Access Compliance Report Public Rights-of-Way (RR Crossings)

Intersection ID: 10025402	Main Street: E_BLAND_ST	Location: N/A
ADA ID: 1B982C0CEFF8	Overall Compliance: No	Severity Score: 0.0
Codes/Mitigation Info/Possible Solution		Field Measurements/Component Compliance

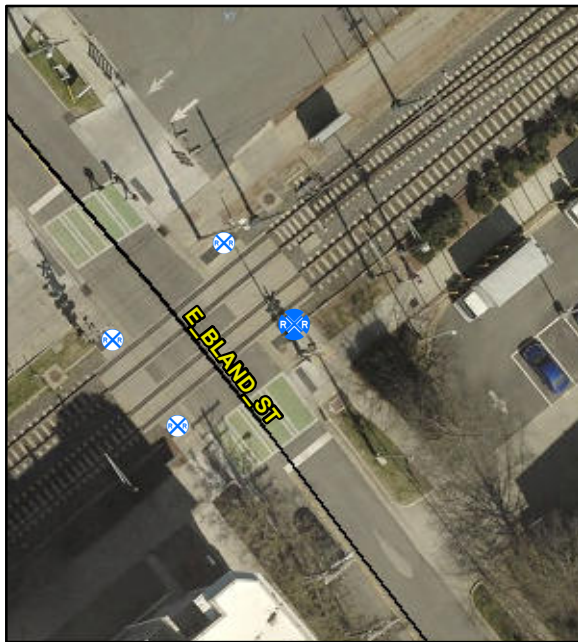
Remove & Replace Detectable Warning System. Provide Pedestrian Gate. Remove & Replace Walking Surface Adjacent to Rail.

R302.7.4, R305.2.5

Compliance	Description	Data
Yes	DWS Provided?	Yes
Yes	DWS Contrast?	Yes
Yes	DWS Width (in)	Yes
Yes	DWS Length (in)	36.0
No	DWS Offset (in)	29.0
No	Pedestrian Gate?	No
N/A	DWS Outside Gate?	No
N/A	Rail Type?	LightRail
No	Flangeway Gap (in)	3.0
Yes	Sidewalk Width (in)	67.0
